ARKANSAS POWER AND LIGHT COMPANY

ARKANSAS NUCLEAR ONE - UNIT 1

AMENDMENT TO FACILITY OPERATING LICENSE

CHANGE NO. 2 TO THE TECHNICAL SPECIFICATIONS

ARKANSAS POWER & LIGHT CO ARKANSAS NUCLEAR ONE-UNIT 1	OPERATIONAL POWER IMBALANCE ENVELOPE	FIG.NO. 3.5.2-3

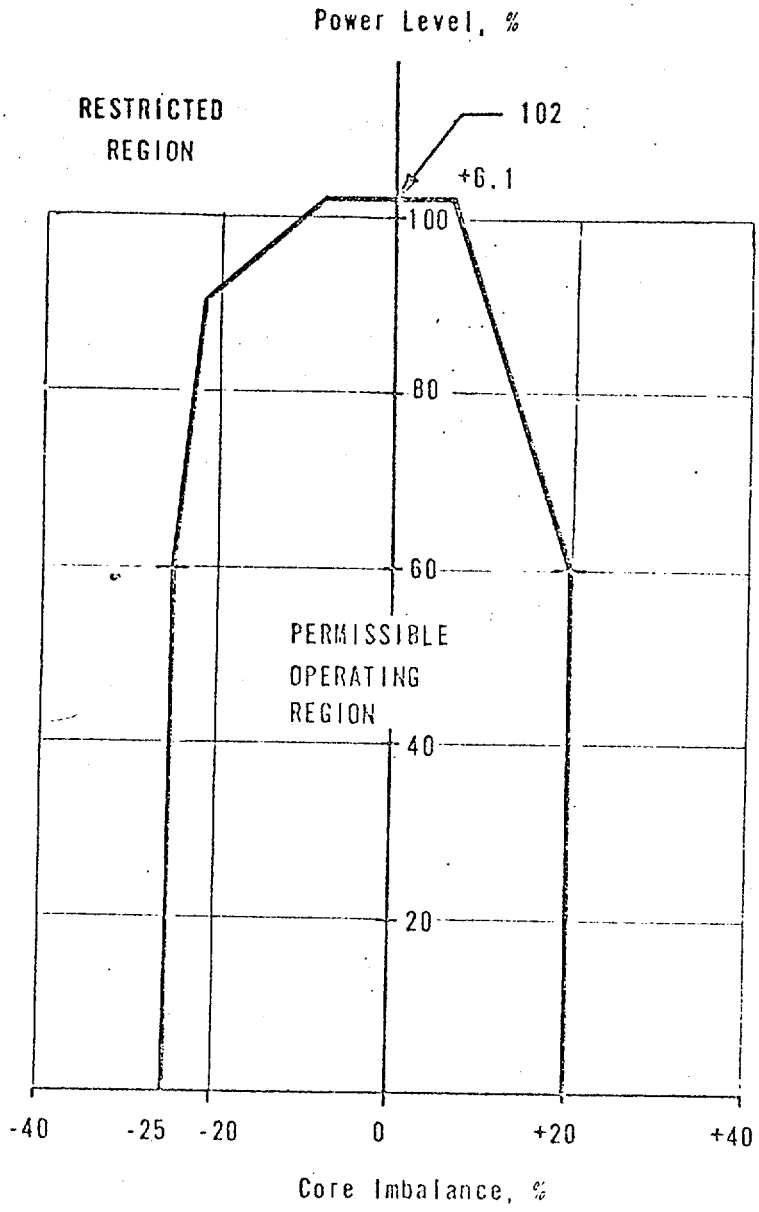
(5) Figure No. 3.5.2-3 - The change in the permissive operating region for power imbalance reduces the allowable operation to be compatible with the protective system maximum allowable setpoints. The change to this figure does not change the allowable reactor operation since the reactor had to be operated within the more restrictive limits established for the reactor protective system. The change is acceptable.

(5) Figure No. 3.5.2-3 - The change in the permissive operating region for power imbalance reduces the allowable operation to be compatible with the protective system maximum allowable setpoints. The change to this figure does not change the allowable reactor operation since the reactor had to be operated within the more restrictive limits established for the reactor protective system. The change is acceptable.

3.5.2.6 Reactor Power Imbalance shall be monitored on a frequency not to exceed two hours during power operation above 40 percent rated power. Except for physics tests, imbalance shall be maintained within the envelope defined by Figure 3.5.2-3. If the imbalance is not within the envelope defined by Figure 3.5.2-3, corrective measures shall be taken to achieve an acceptable imbalance. If an acceptable imbalance is not achieved within four hours, reactor power shall be reduced until imbalance limits are met.

The power-imbalance envelope defined in Figure 3.5.2-3 is based on 1) LOCA analyses which have defined the maximum linear heat rate (see Figure 3.5.2-4) such that the maximum clad temperature will not exceed the Interim Acceptance Criteria and 2) the Protective System Maximum Allowable Setpoints (Figure 2.3-2). Corrective measures will be taken immediately should the indicated quadrant tilt, rod position, or imbalance be outside their specified boundary. Operation in a situation that would cause the interim acceptance criteria to be approached should a LOCA occur is highly improbable because all of the power distribution parameters (quadrant tilt, rod position, and imbalance) must be at their limits while simultaneously all other engineering and uncertainty factors are also at their limits.* Conservatism is introduced by application of: 2
